# **UT to Town Creek Restoration Project – Option A Final Year 6 Monitoring Report**

**DMS Project ID Number – 94648; NC DEQ Contract No. 003277**

**Subject:** Response to DMS Comments for MY6 Draft Report  
UT to Town Creek Mitigation Site, Stanly County  
DMS Project #94648, DEQ Contract #3277

DMS MY6 Draft Report Comments:

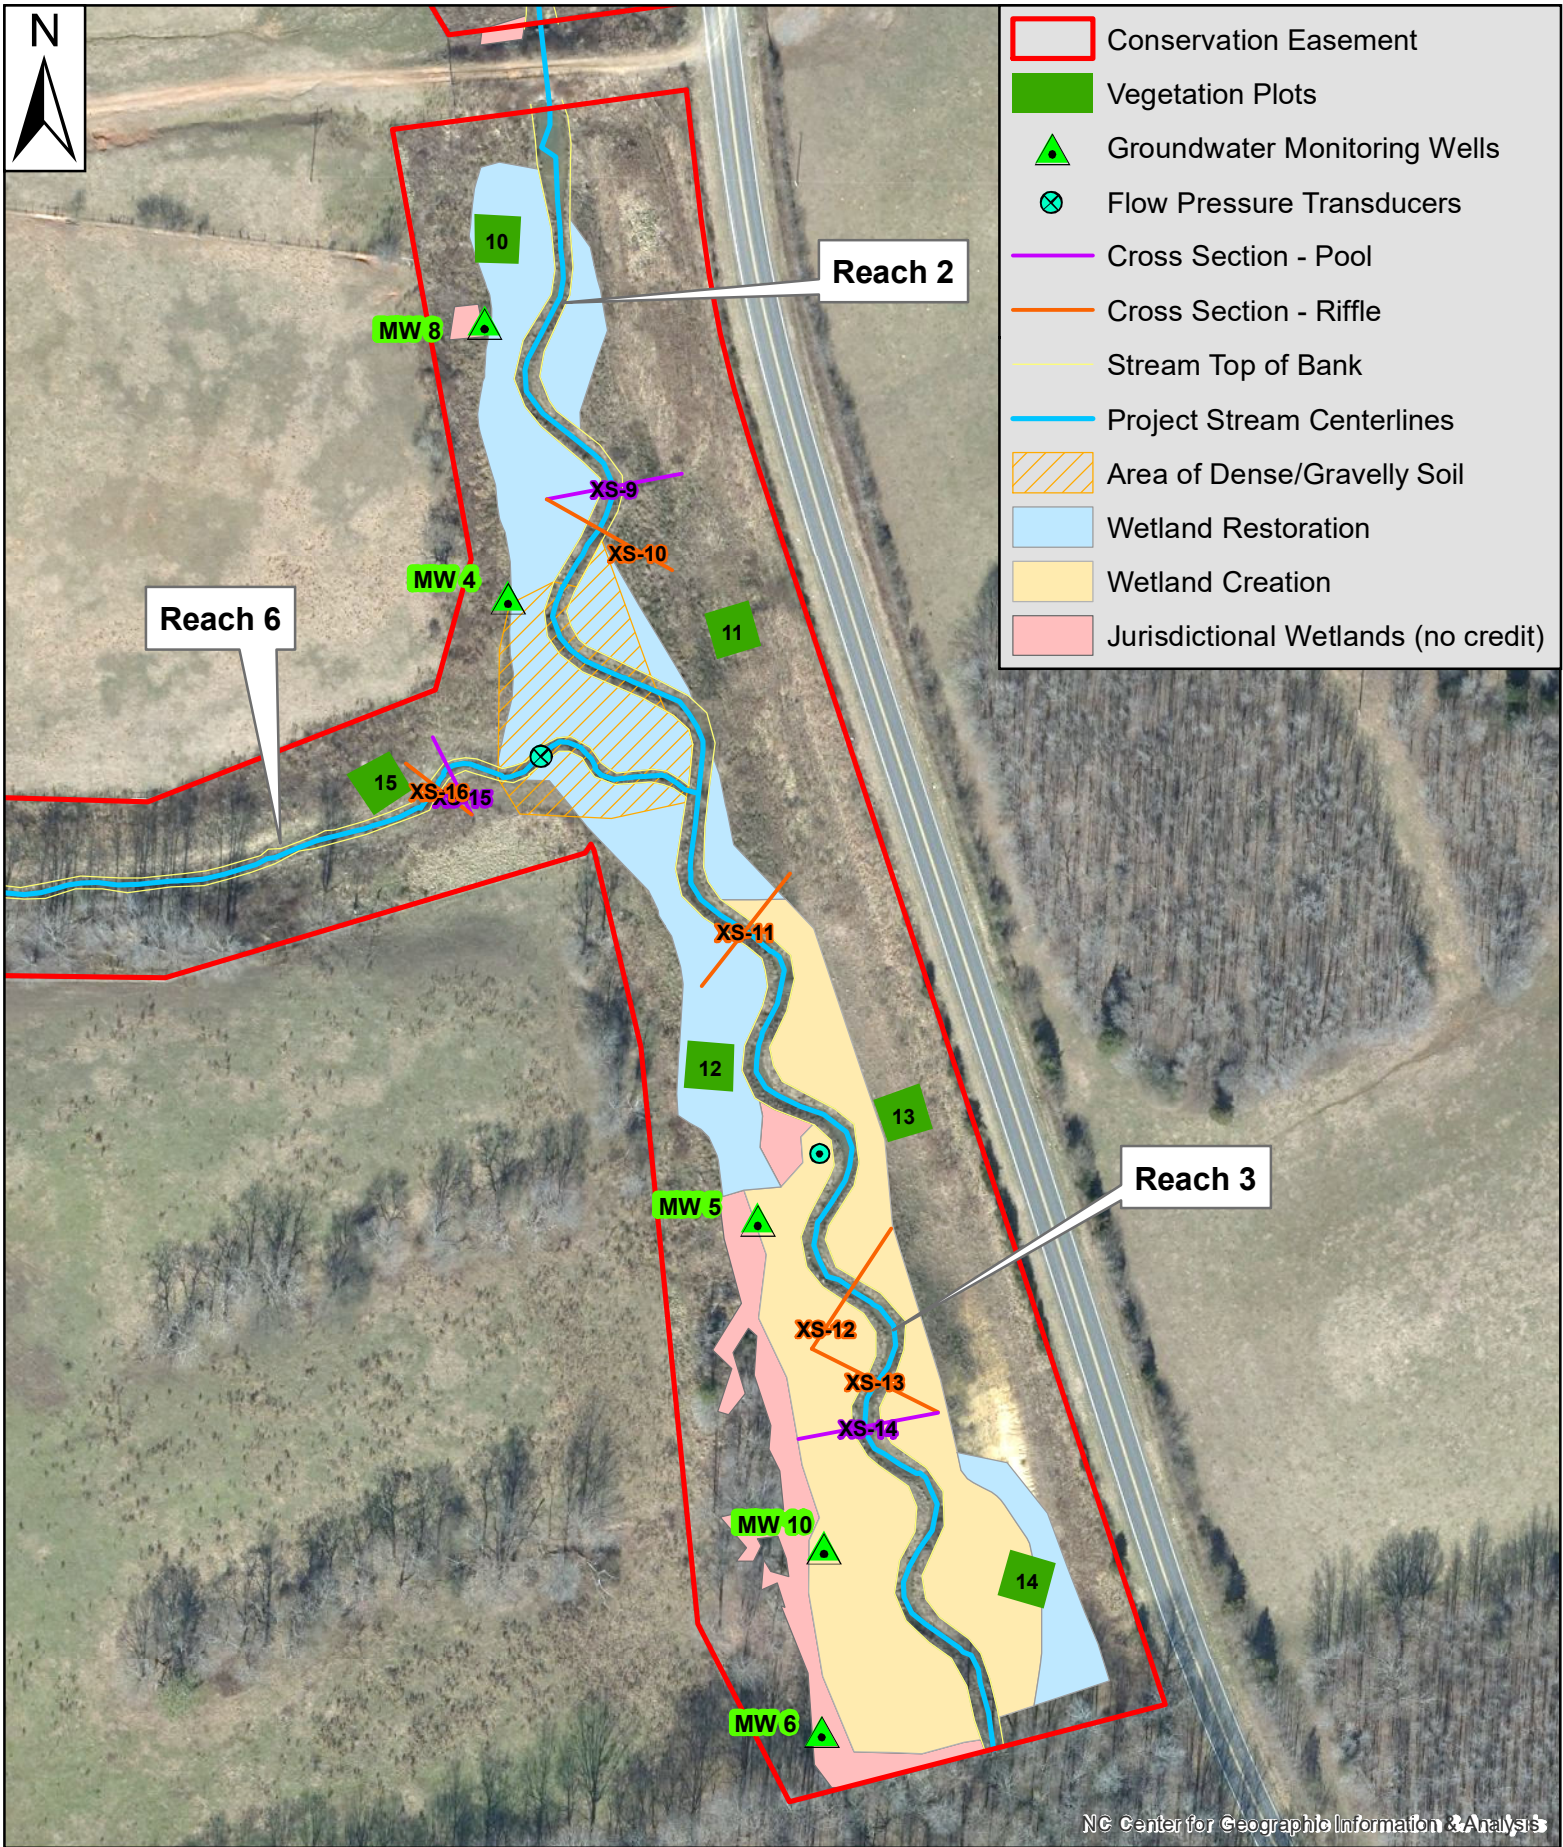
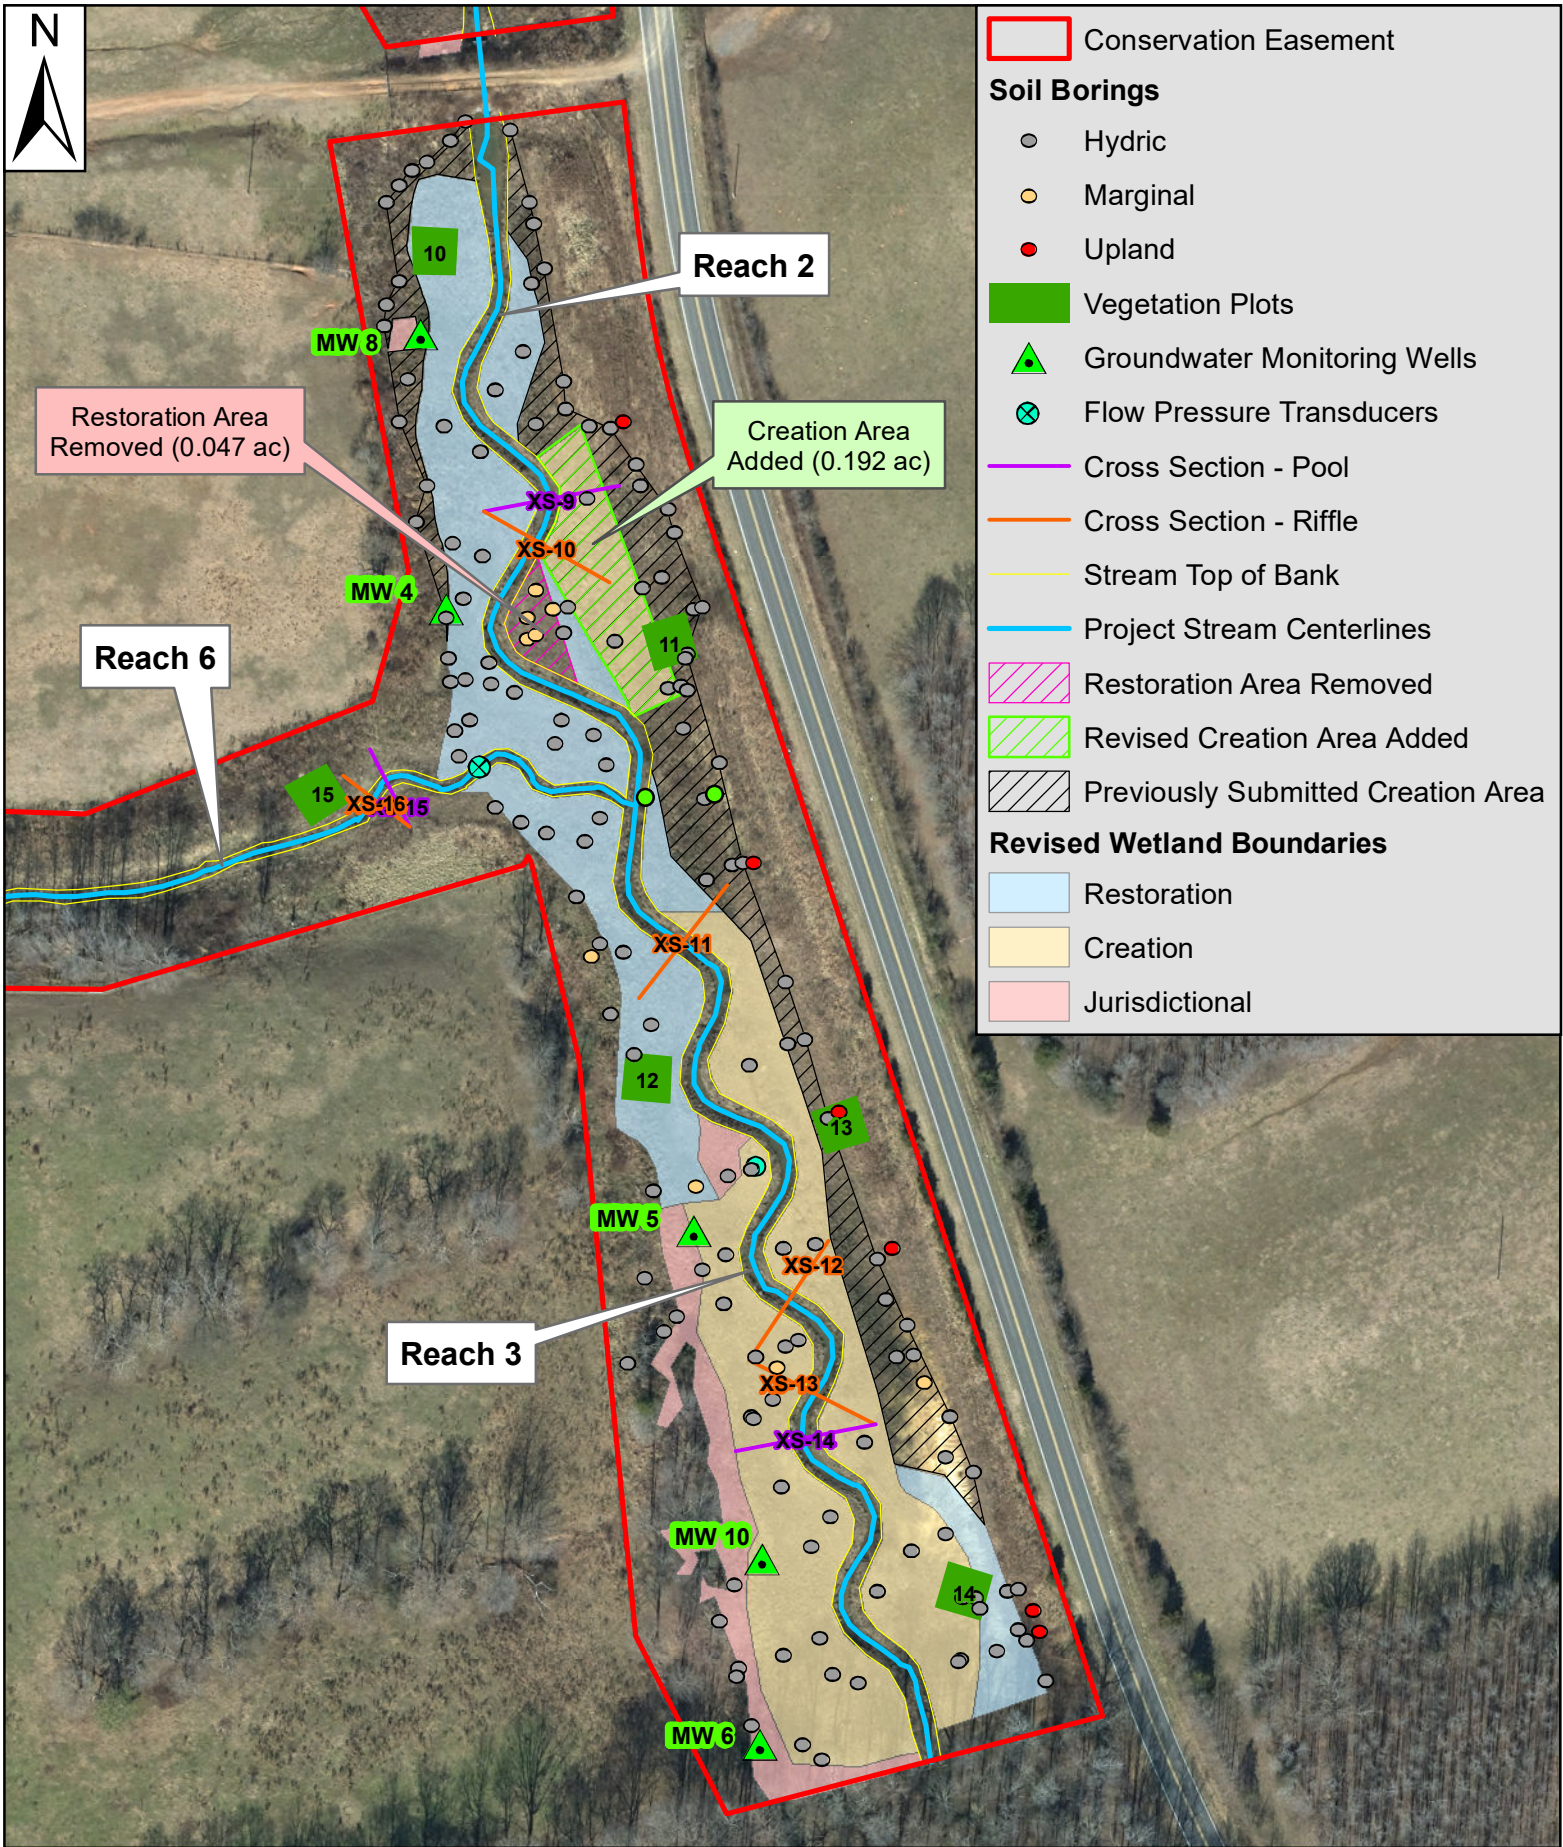
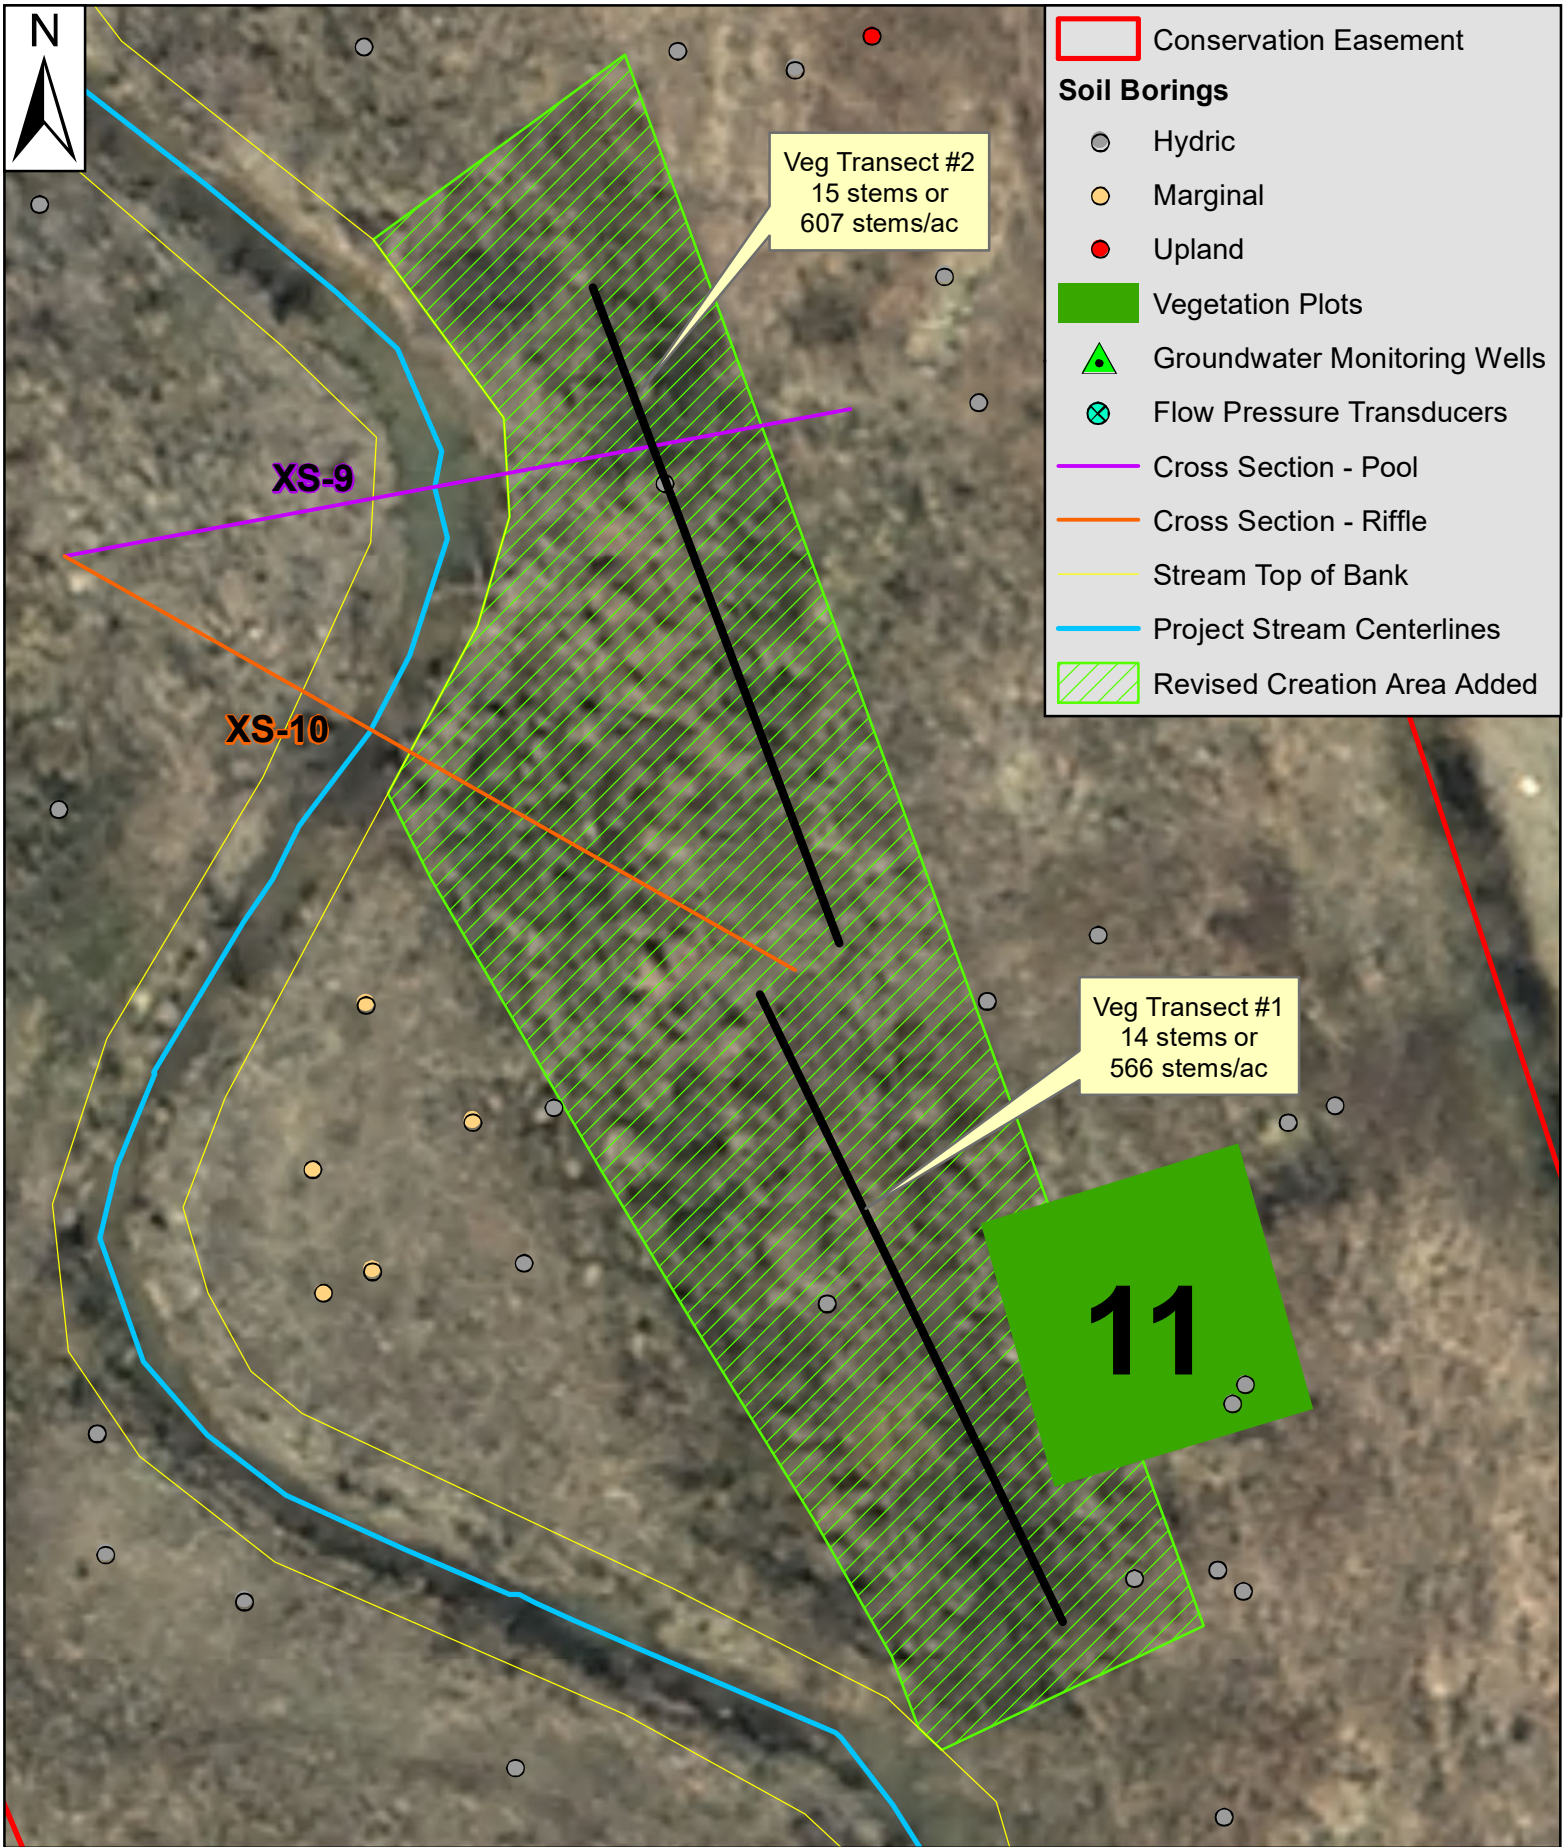
However, during the IRT site visit as part of project closeout activities on 6/3/21, a portion of the newly added areas of Wetland Creation at the southern extent (below XS-11) were questioned by the IRT. These areas did not appear as ‘wet’ as the other areas added and the IRT requested that if they were ultimately to be included as credited wetland area, they would require additional groundwater monitoring. The meeting minutes from that site visit were approved on 7/7/21 and provide a more detailed summary of the discussion that day. They can be found in the Appendix of the MY6 report.

Given the feedback from that IRT walkover, Baker elected to remove all of the Wetland Creation area that was considered questionable, as well as much of the rest of the newly added Wetland Creation area, excepting a small portion of the very wet area around XS-10 and Veg Plot 11. This area is actually quite near the Restored wetlands being removed from crediting, and was the original area specifically pointed out by Mac Haupt (of DEQ) during the first IRT walkover in 2019 as being what he would

recommend Baker add as recompense for any lost wetlands. It is also by far the wettest portion of the added Wetland Creation area, has abundant tall vegetation, and was readily accepted by the IRT during the walkover in June of 2021. At an area of 0.192 acres, it adequately covers the credits lost from the removal of the nearby Restored wetlands. Figure 2 shows this final area as well as all of the previously added Creation areas (which have subsequently been *removed* from consideration) and their previous soil borings. This very limited area of Wetland Creation (only a small subset of the original) is being submitted for the purpose of facilitating a smoother closeout after MY7. Photos of this area were collected during the previous field investigation in January 2021 and have been included again here, while more recent photos were taken of this area in November 2021 and are also included here.

Additionally, as per IRT request during the field visit in June 2021, the revised Creation area addition was assessed for vegetation through the collection of 2 temporary vegetation transects, each approximately the size of a standard monitoring veg plot. As noted above and as documented in the photolog, the area as a whole has quite tall, abundant vegetation consisting of sycamore, persimmon, blackgum, green ash, swamp chestnut oak, willow oak, box elder, tulip poplar, buttonbush, silky dogwood, and black willow, with thick herbaceous vegetation dominated by tearthumb, soft rush, and woolgrass (amongst other rushes and sedges). These species are overwhelmingly rated as wet for their facultative indicator status for the Eastern Mountains and Piedmont region. The first vegetation transect identified 14 stems (for a density of 566 stems/ac), all but 3 of which were well over 6 ft tall. The second vegetation transect identified 15 stems (for a density of 607 stems/ac), of which 8 were well over 6 ft tall (and the remainder averaging about 4 ft tall). Figure 3 shows the approximate location of the transects within the revised Creation area.

As previously noted in the original wetland adjustment memo, the Creation Wetland area being added will be credited at a 3:1 ratio, while the Restored Wetland area being removed was credited at a 1:1 ratio. The newly revised wetlands on the project total 2.513 acres for the Restoration component and 1.752 acres for the Creation component, for a total of 3.097 Riparian Wetland Credits. Baker is contracted for 3.0 wetlands credits. The revised wetland credits are shown below in Table 1:
